# City of Richmond Department of Planning & Development Review

**PROPOSAL:** Final location, character, and extent review of a new equestrian center for the Richmond Police Department.

**CITY OF RICHMOND, VIRGINIA  
RICHMOND POLICE EQUESTRIAN CENTER**

**Project Narrative  
For  
Urban Design Committee 'Final' Review**

**APPENDIX A**  
**Exterior Renderings**

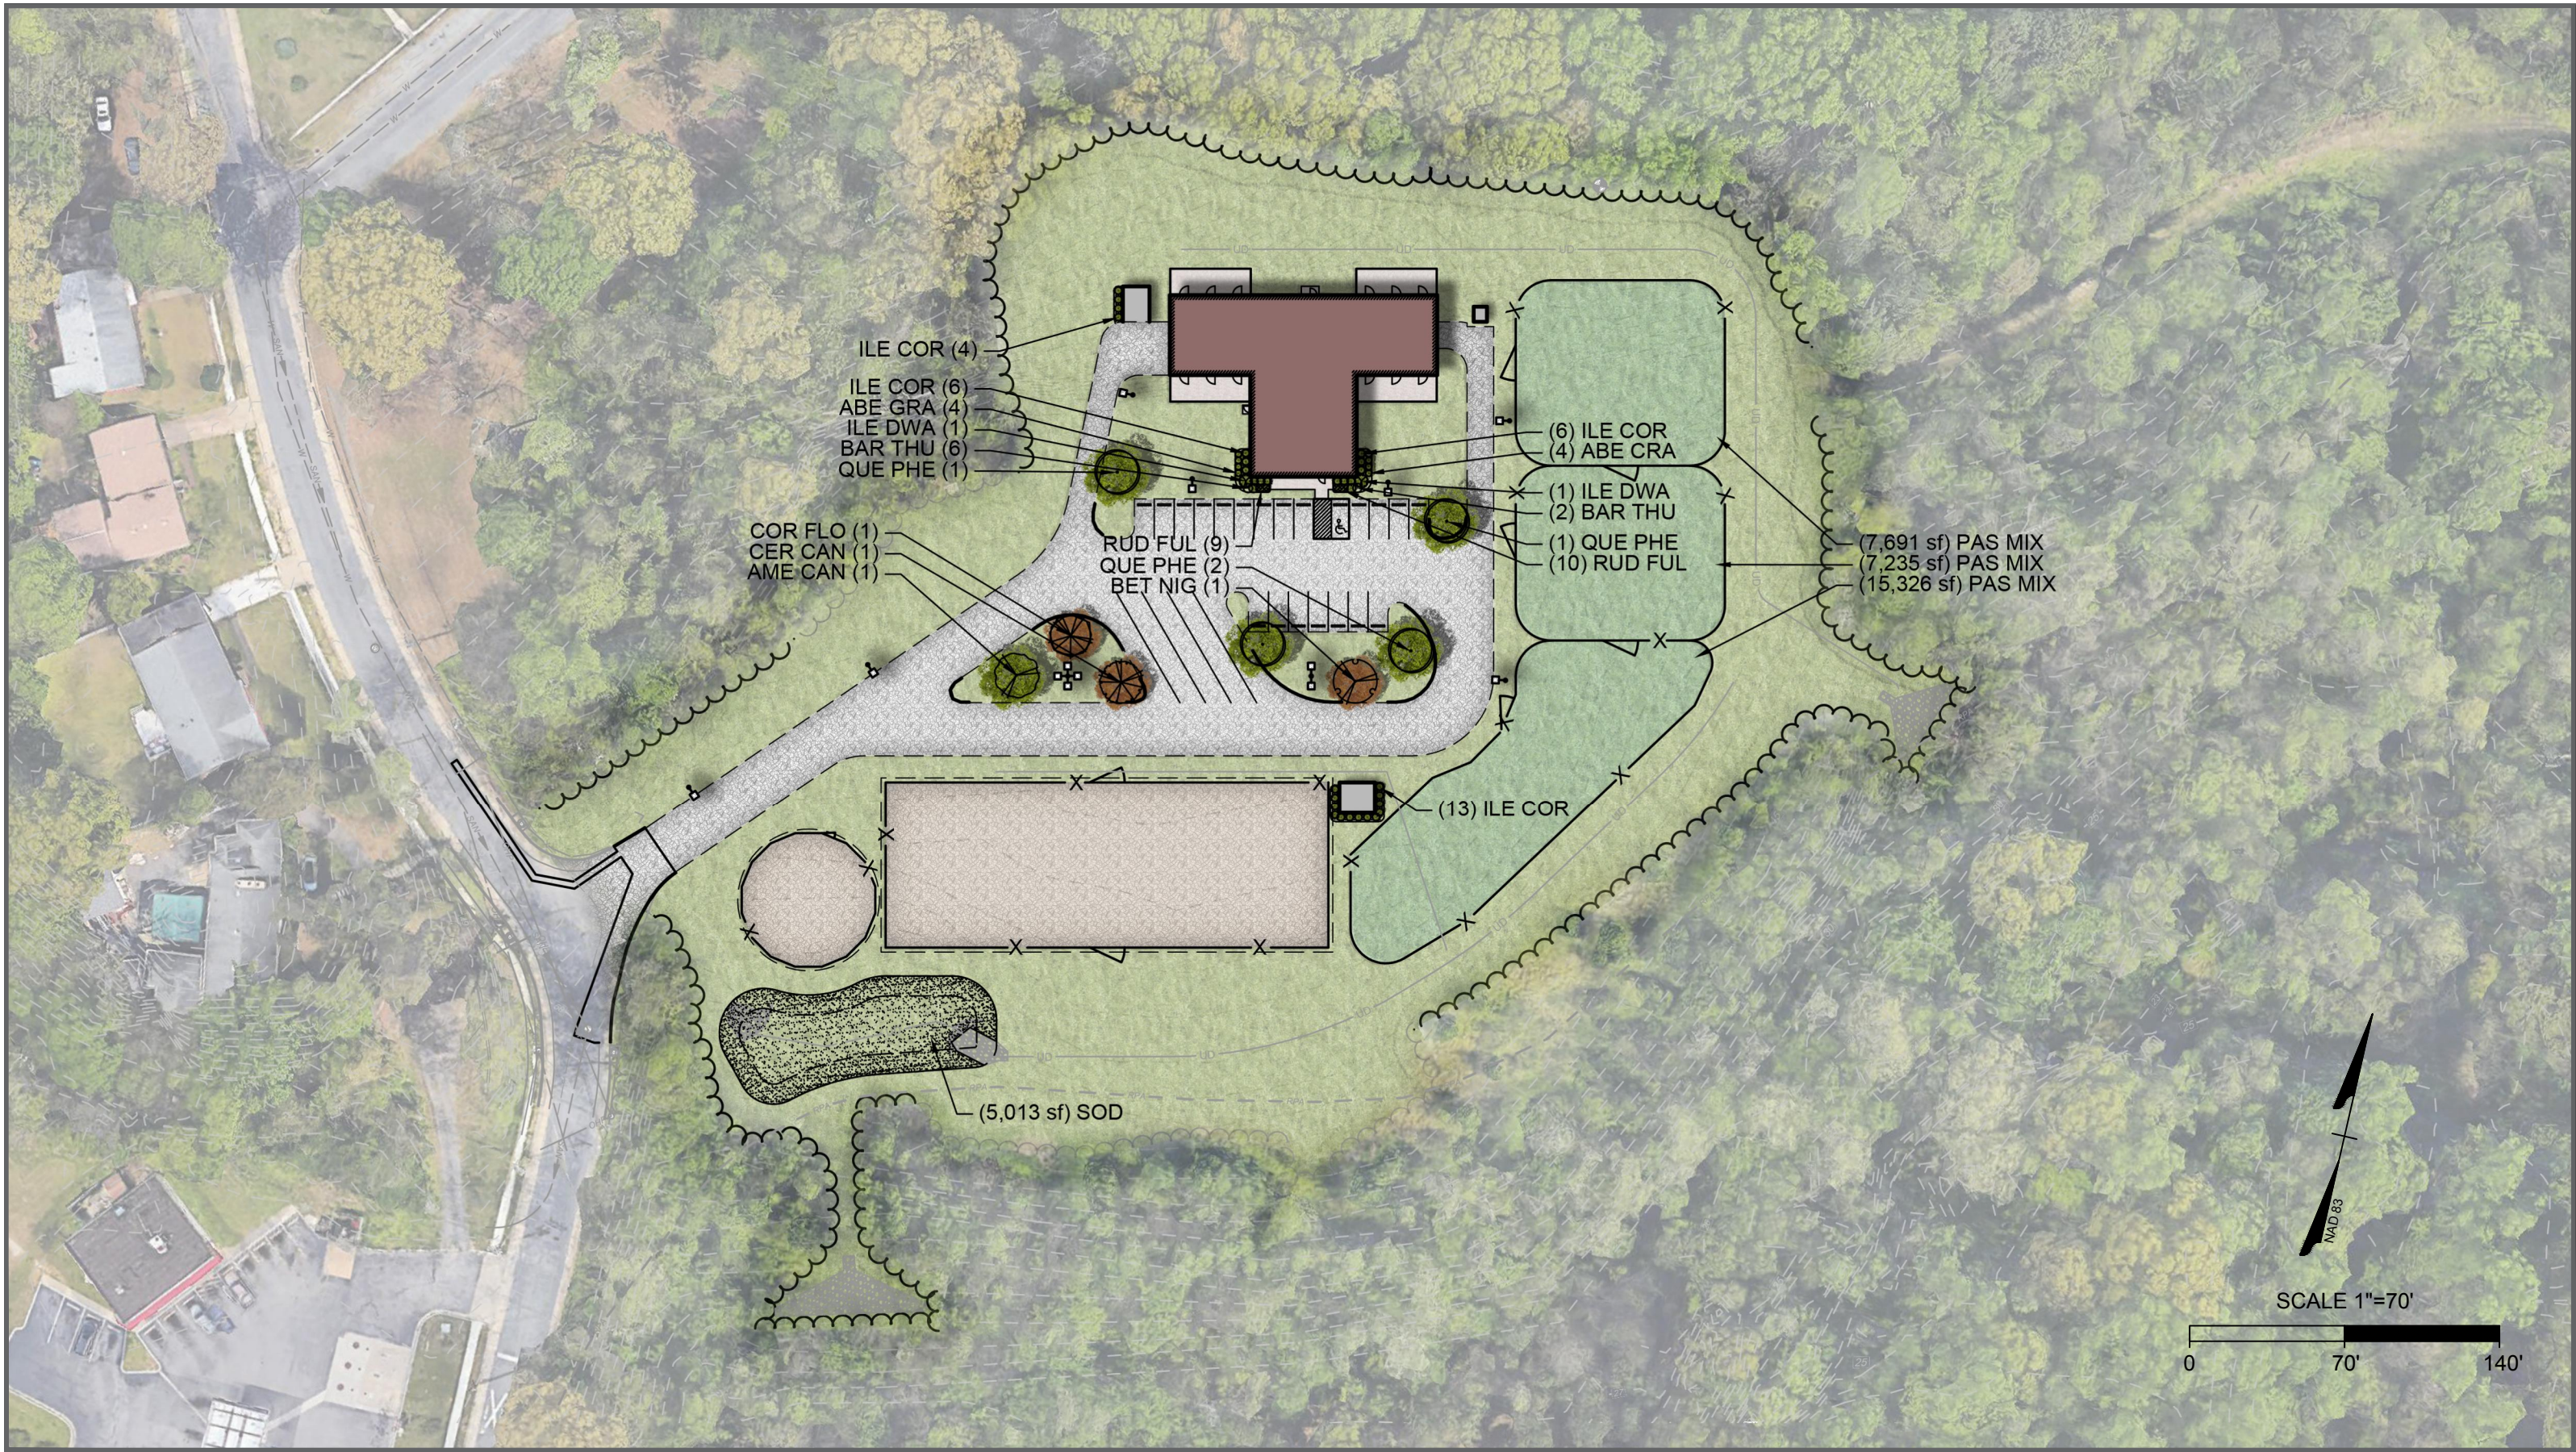
5. The site grading is difficult to understand, could the design team provide a rendering that more accurately reflects the site grading.

Please refer to the updated rendering included with this submission that more accurately reflect the proposed site topography.

# UDC Landscape Plan

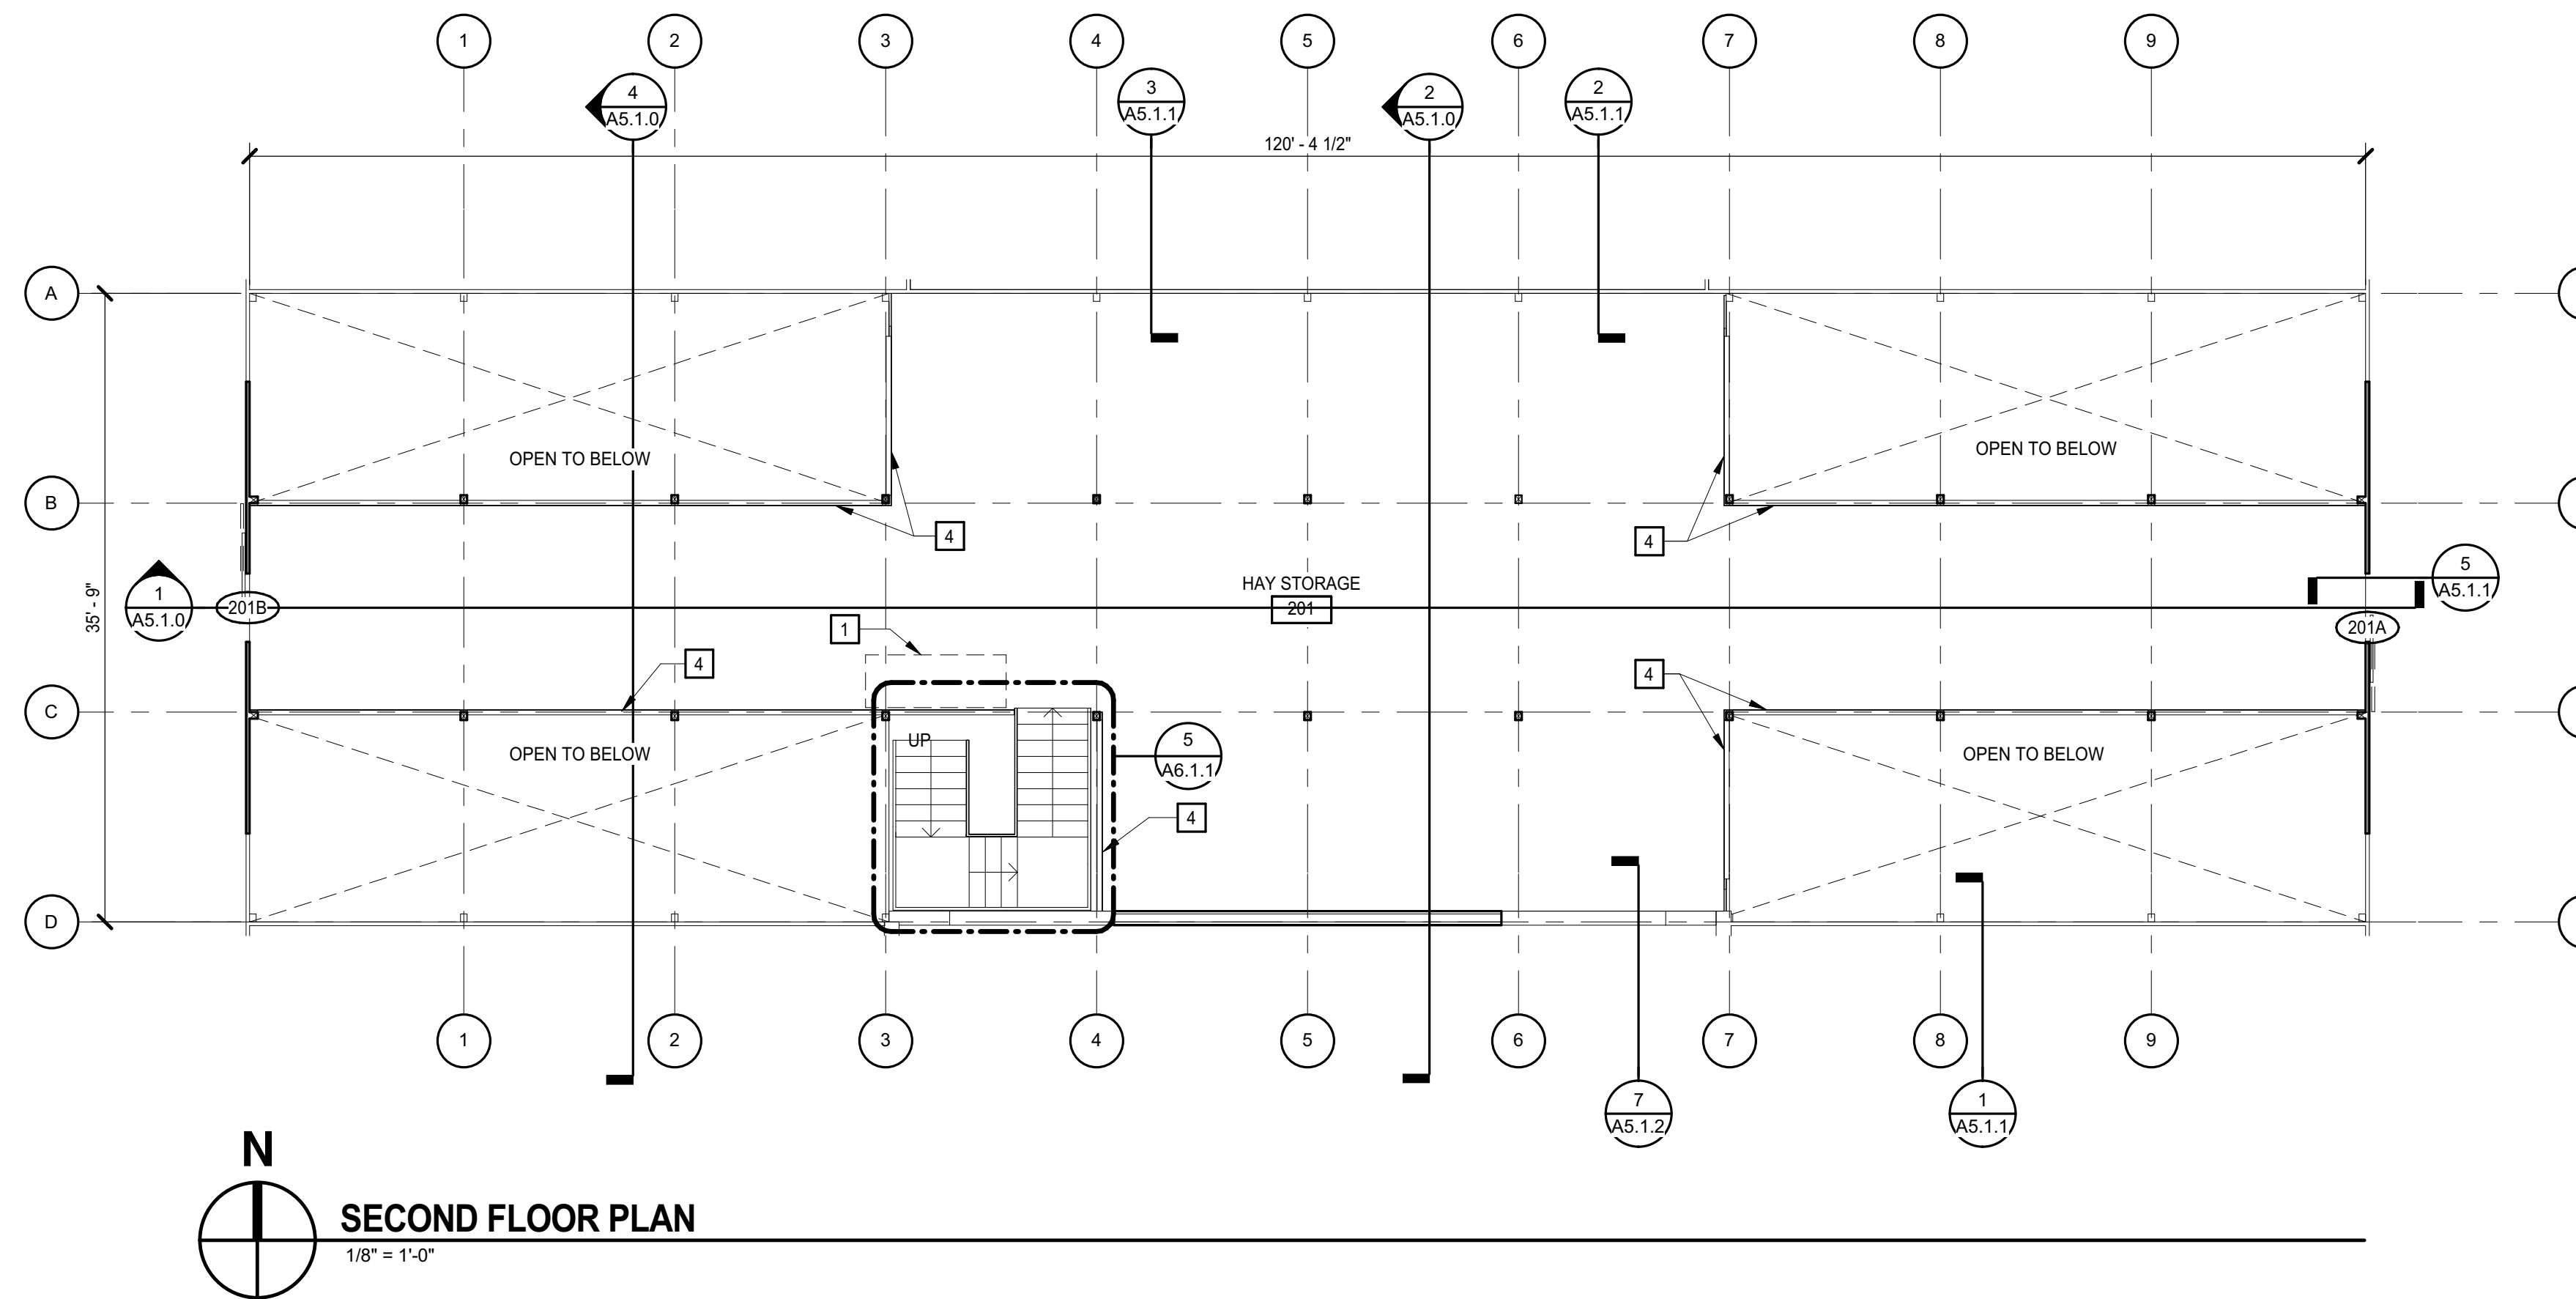
2. The landscape design should be minimalistic and prioritize shade trees in the parking areas.

This is reflected in the landscape design for the project.
